Administrative Change Approval Form Order

East Port Water Reclamation Facility Expansion

Contract #:	2023000485	Change Order #:	3
Original Contract:	\$106,188,600.00	Original Contingency:	\$5,309,430.00
Previous Change Orders:	\$249,567.74	Previous Contingency Changes:	\$249,567.74
This Change:	(\$107,604.73)	New Contingency Balance:	\$5,059,862.26
Revised Contract Amount:	\$106,330,563.01	Original Contract Time:	900 days
Current Completion Date:	12/17/2026	Previous Additional Time:	159 days

CCU Change Order Request
East Port WRF Expansion - Poole and Kent
Change Order #3

PROPOSED CONTRACT MODIFICATION (PCM) No. 10

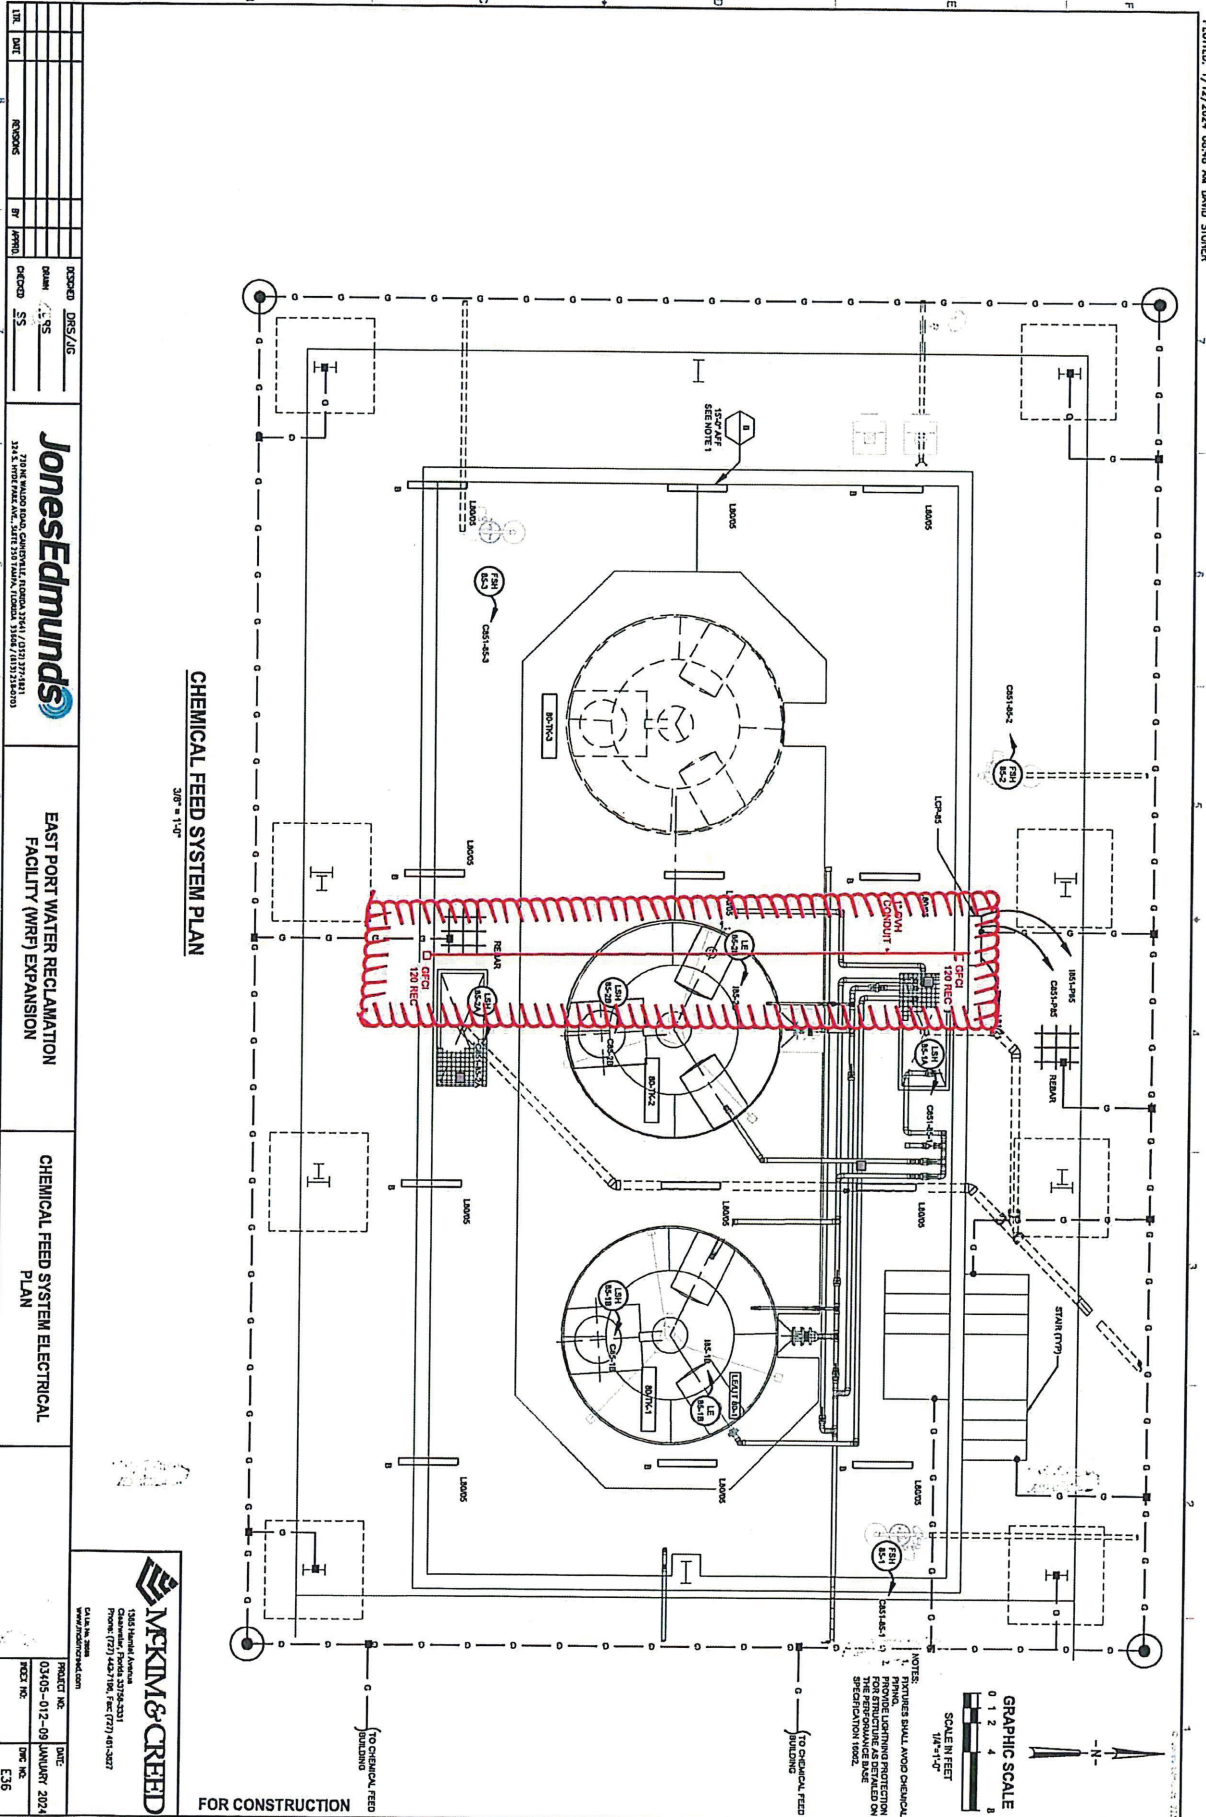
DESCRIPTION OF MODIFICATION: Please submit an equitable itemized proposal for the following revisions:

- Sump Pumps By Others*
1. Reconfigure 4-Inch Gravity drains from Sump area.
 - * 2. Furnish and Install (2) 120 VAC Sump Pumps, Conduit, Wiring and GFCI Receptacles.
 3. Provide Credit / Deduct for Omitted Drain Fittings, Valve, and Miscellaneous Appurtenances.

REASON FOR MODIFICATION: Eliminate potential for inadvertent CL2 disposal.

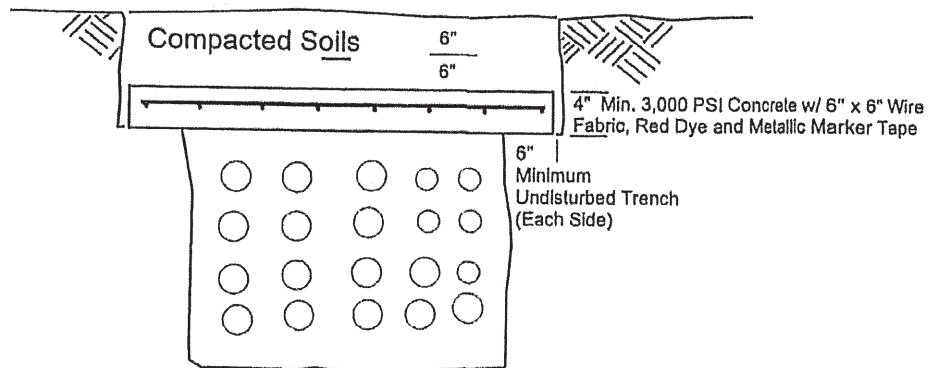
This change order request is based on the drawing by GS Fruecht dated 11-05-2024. Revised duct bank eliminating concrete encasement and replacing with a 4" Shock Pad.

**PROPOSED CONTRACT MODIFICATION (PCM) No. 21**

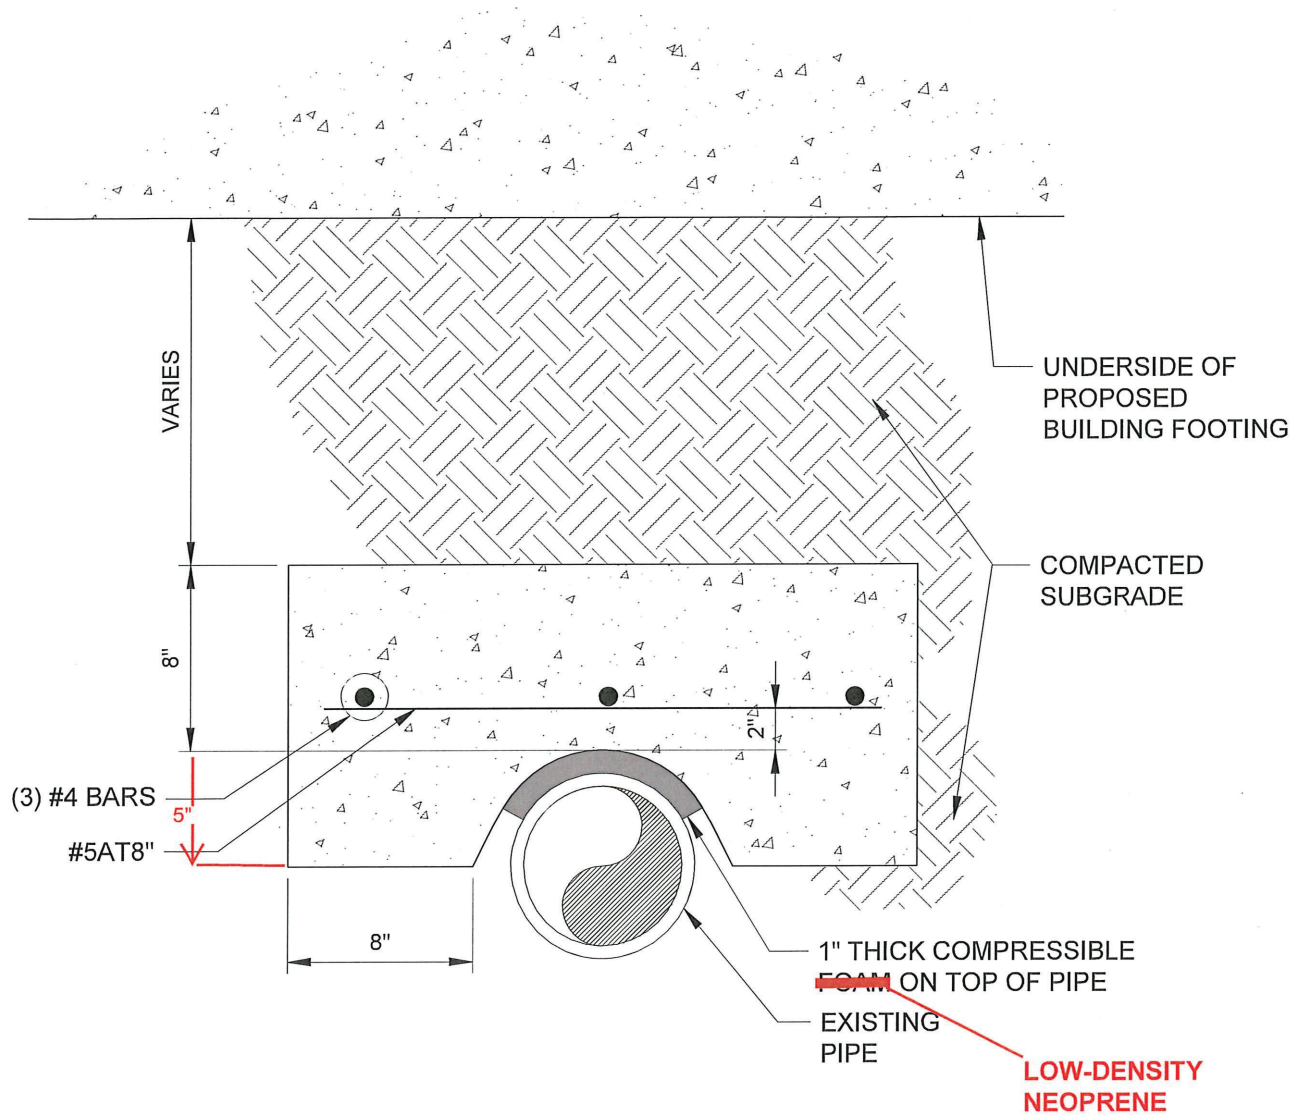
DESCRIPTION OF MODIFICATION: Please submit your proposal for an equitable adjustment in the contract amount and/or performance time in accordance with the following:
to furnish and install reinforced concrete shock pads at select areas over the existing 8" diameter piping. Please refer to details which identifies the profile, the extents, and the required low-density neoprene insulator.

REASON FOR MODIFICATION: Found existing pipe within footprint of new construction.

SK-1

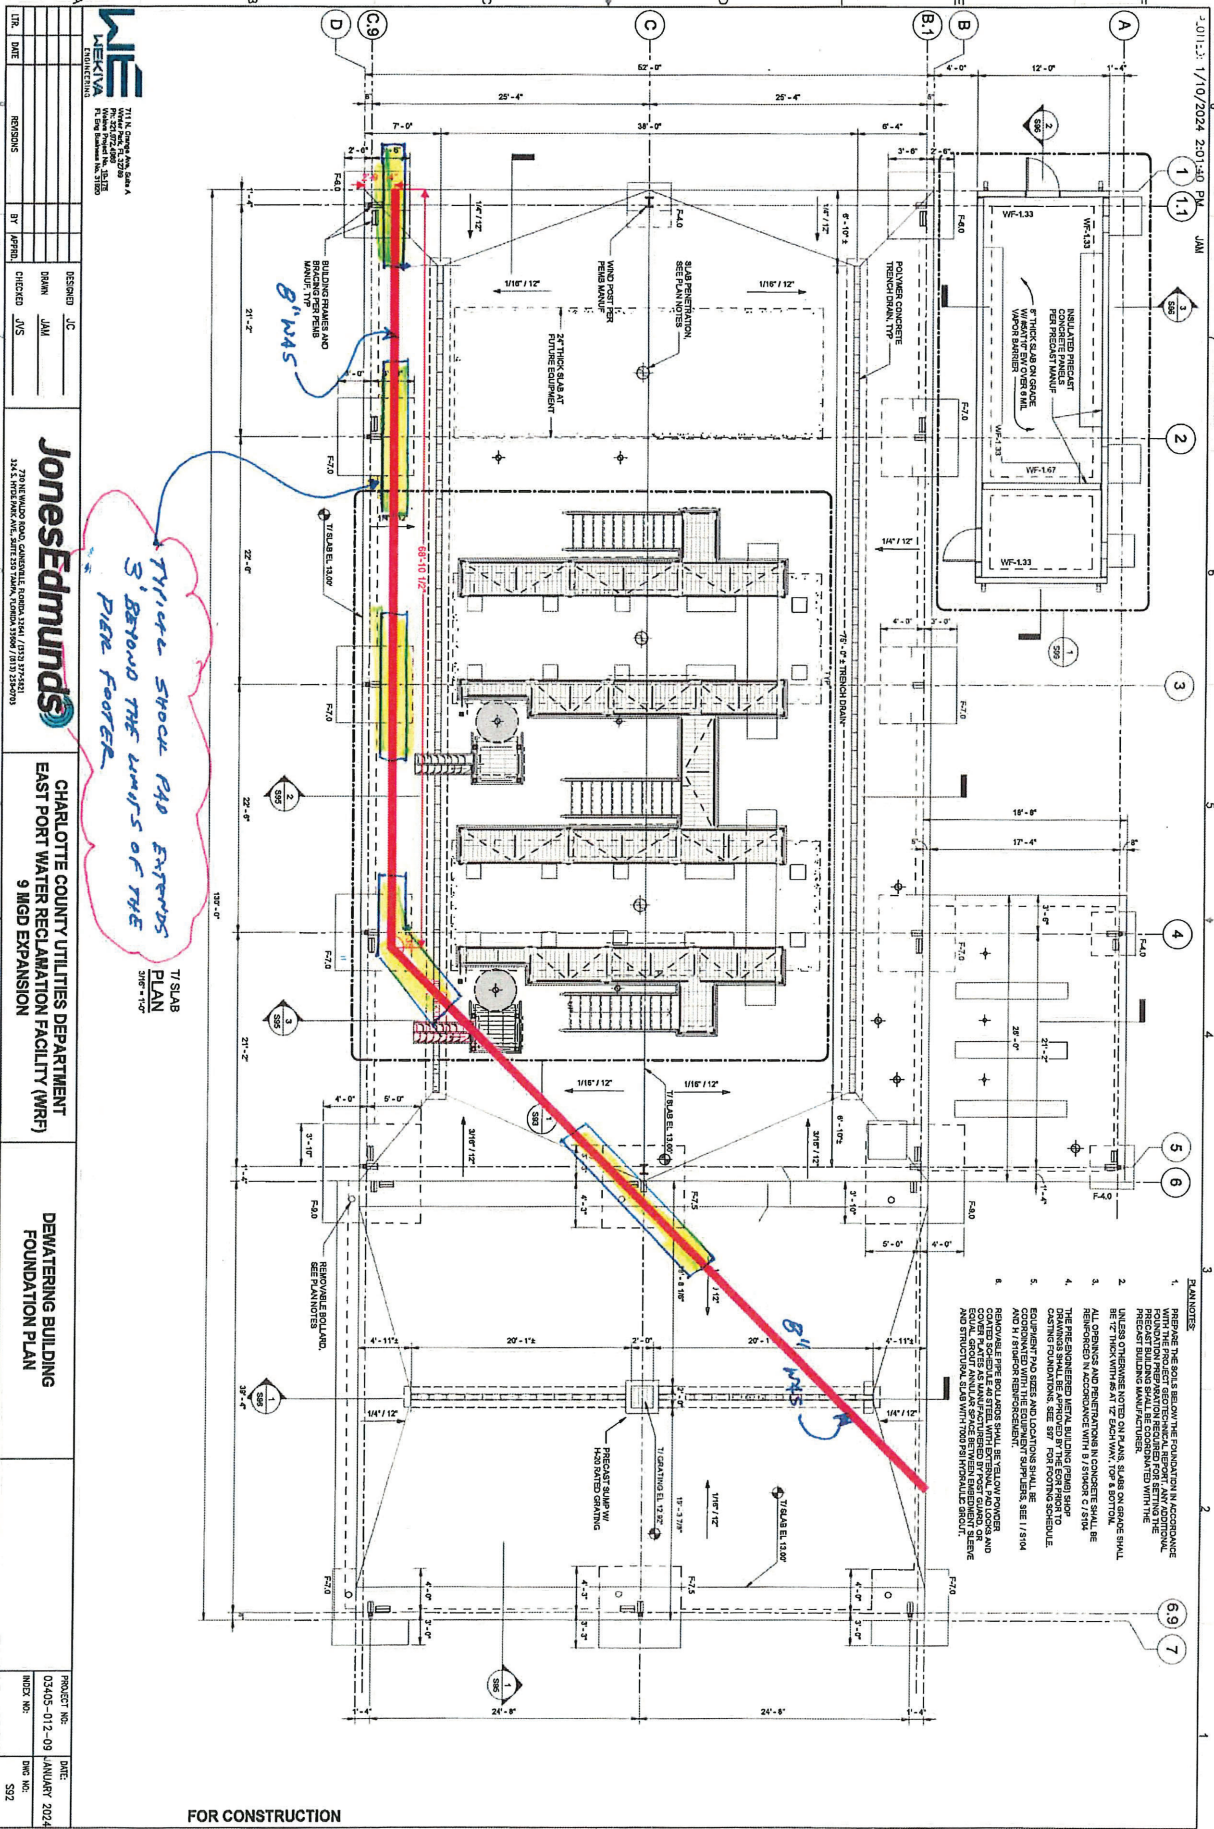
THICK STOCK PILE EXTENDS 3' BEYOND THE LIMITS OF THE PIER FOOTER
